RECEIPT DATE: 12/12/17 **ONSITE SEWAGE DISPOSAL SYSTEM** P 562355A

PROPERTY ADDRESS: 16463 Frederick Road

SUBDIVISION: Stanley Miller Property LOT: 12 TAX ID: \_\_\_\_\_

TITLE: SEPTIC PLAN

**PUMP/SEPTIC TANK LEVEL**

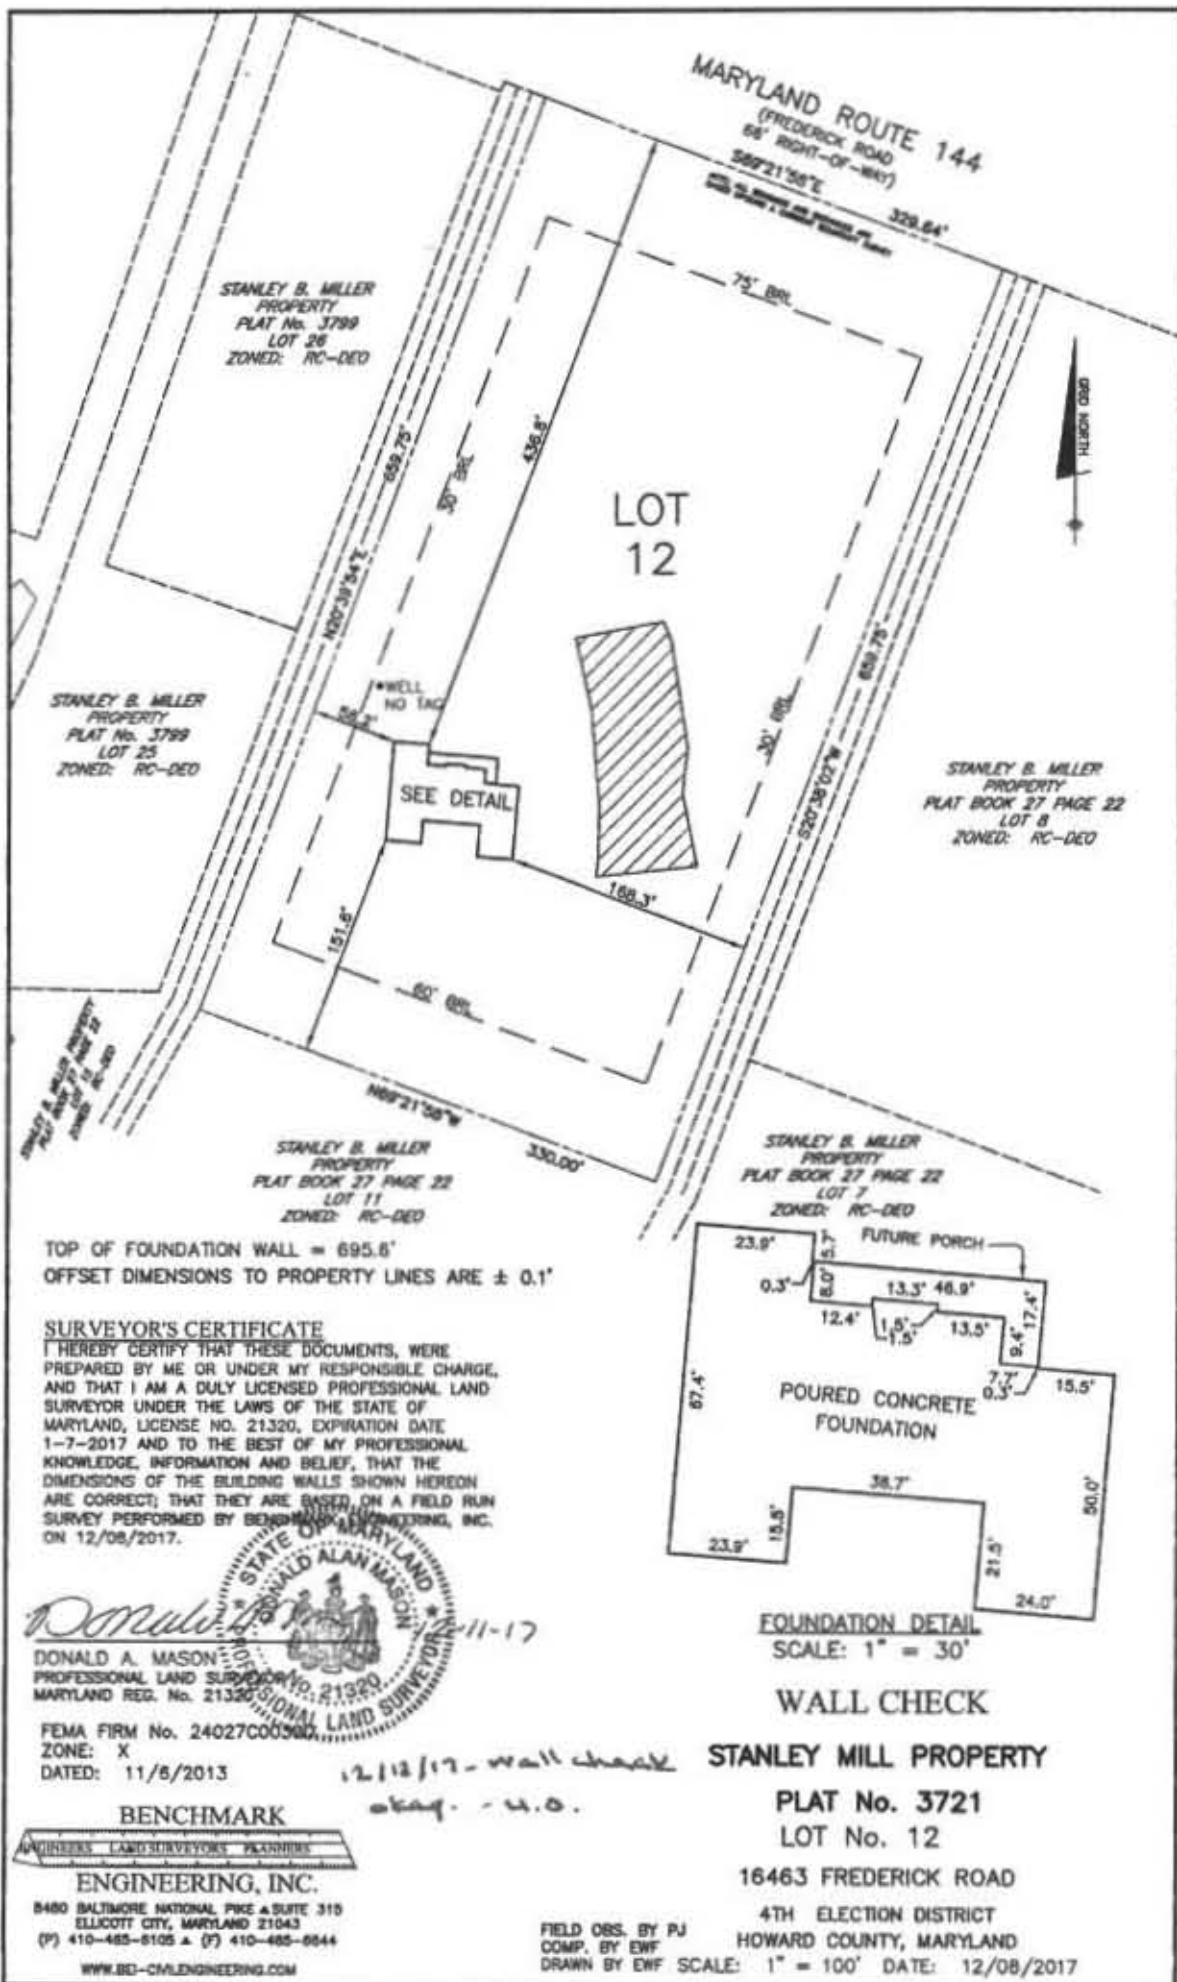
3/2/18 Met Freedom on site for layout. SDA stakes present. Shot contour + laid out 2 x 85' trenches. D-box to go in middle of upper SDA boundary. (SC)

**INSTALLATION:** 3/5/18 Housse connection made. Tank + D-box set and pipe laid between Freedom digging + adding stone to T2; 3' wide, 2.5' to stone, 6.5' bottom. Using laser to check depths. (SC) 3/6/18 T1 complete + left open for inspection. 3' wide, 2.5' to stone, leveled speed levelers in D-box. T1 outlet pipe in D-box leaking connection. Freedom patched w/ hydraulic cement. [Corrective action + completed.] (SC)

**WALL CHECK**

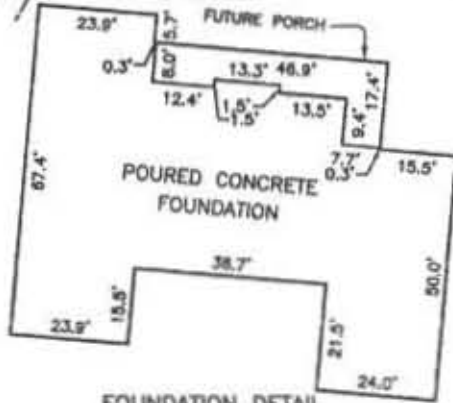
12/12/17 - wall check  
okay - u.o.

**WALL CHECK**

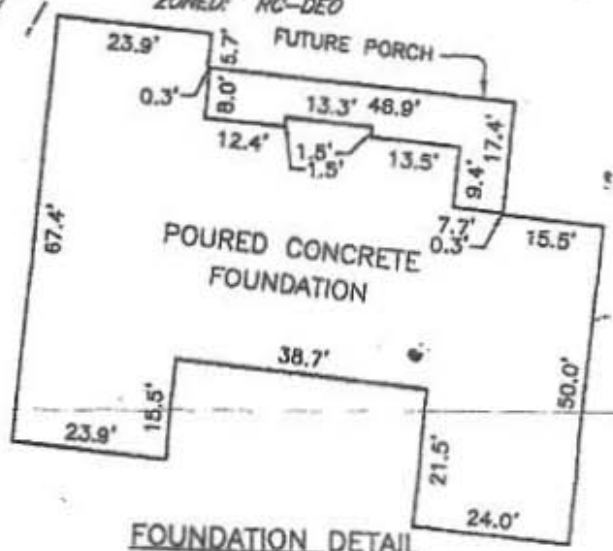
REVISÉ  
 Date: 3-7-18  
 Comments: Change tank from above ground to underground. Same location

500 gal  
 Under ground  
 Propane tank

LOT 12  
 Approved for UAT/B18000437  
 3/15/18
